SUBJECT: Forwards response to NRC RAI resulting from 930625 telcon re
 Topical Rept NTH-TR-01, "RETRAN Model Qualification -
 Decrease in Heat Removal by Secondary Sys."

L-93-242

Re: Response to Request for Additional Information Related to Topical Report NTH-TR-01, RETRAN Model Qualification - St. Lucie Plant Unit Nos. 1 and 2 (Docket Nos. 50-335 and 50-389) and Turkey Point Plant Units Nos. 3 and 4 (Docket Nos. 50-250 and 50-251 (TAC Nos. 75082, 75083, 75084 and 75085))

FIGURE 1. ST. LUCIE 1, RCS PRESSURE

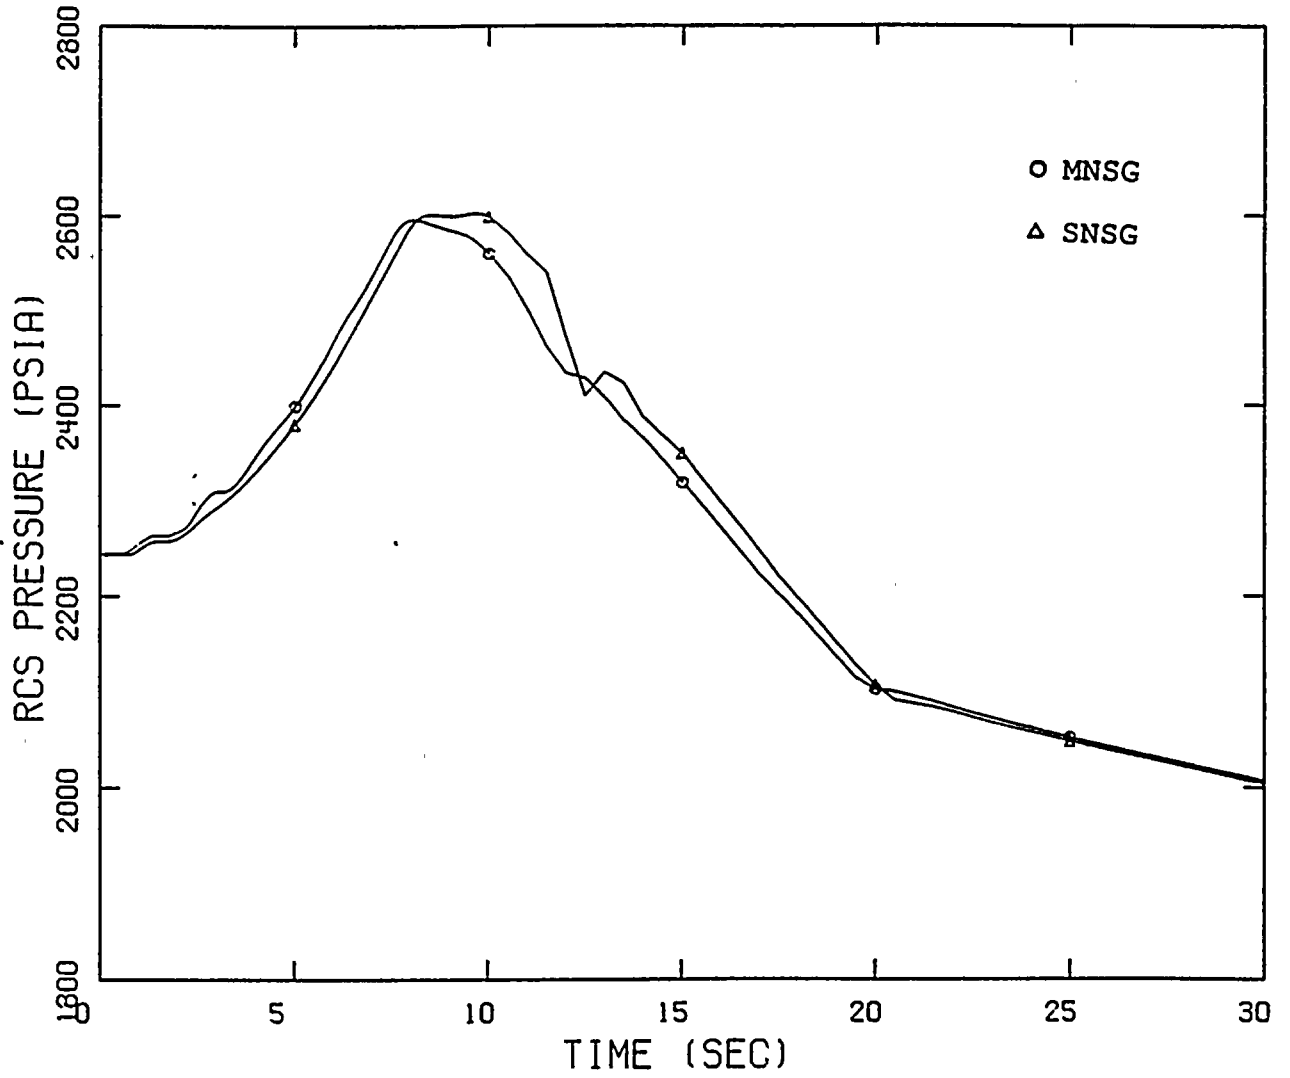
Why is the Single Node Steam Generator model adequate for W and CE plants in the Loss of Condenser type analyses. Plant differences?

Figures 1 through 3 show the comparisons of primary and secondary responses predicted with the SNSG and the MNSG for the St. Lucie Unit 1 Loss of Condenser Vacuum (LOCV) transient. Figures 4 through 6 show the corresponding comparison for the Turkey Point units. Both LOCV transients, described in detail in Reference 1, are based on conservative assumptions, such as instantaneous isolation of the feedwater flow at the beginning of the event.

The St. Lucie LOCV scenario is dominated by an early opening of the Main Steam Safety Valves (MSSVs) which precedes the reactor trip signal and pressurizer safety valve opening on high pressure. The MNSG model, with a 1-second earlier MSSV opening than the SNSG (which opens MSSVs at 6.6 seconds), results in less energy accumulated in the system and therefore less system overpressurization. The impact of this, however, is not significant. The differences in peak pressures predicted by the two models are about 7 psi for the primary system and 3 psi for the secondary system.

Based on the comparisons between the SNSG and MNSG responses illustrated in Figures 1 through 6, it can be concluded that the SNSG model is a valid model for licensing analyses of St. Lucie and Turkey Point Loss of Load type transients. For these events, where the relevant transient time is too short for a significant loss of steam generator inventory to occur and where the level in the steam generator is not a parameter of importance, a detailed steam generator representation is not necessary. The SNSG model provides a response that is very similar to that predicted by the MNSG model but is more conservative and therefore more appropriate for licensing applications. The SNSG is the model which will be used in the FPL methodology for both Turkey Point and St. Lucie licensing analyses of the Loss of Load type events.
